Model: TDSU Buildings & CIP

Product Bulletin # TDS-146

# 140M Circuit Breaker

Figure 2: Circuit Breaker Label

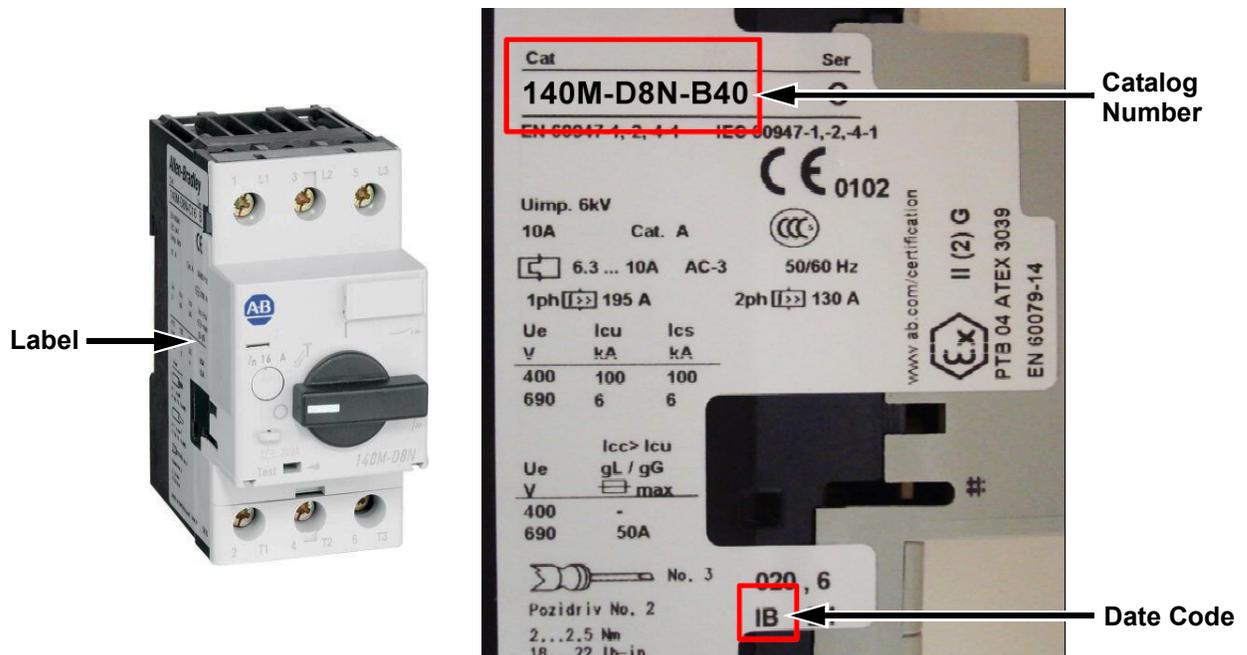
3. Locate the circuit breaker label on the left side of the assembly, see Figure 2.
4. Record the following information to identify if unit is affected by this alert:

Catalog Number	Date Code

5. Contact RigLine 24/7™ Support to have the circuit breaker replaced if the following catalog number and date code are found:
  - Catalog number: **140M-D8N-B40**.
  - Date Code: **IB** or **JB**.
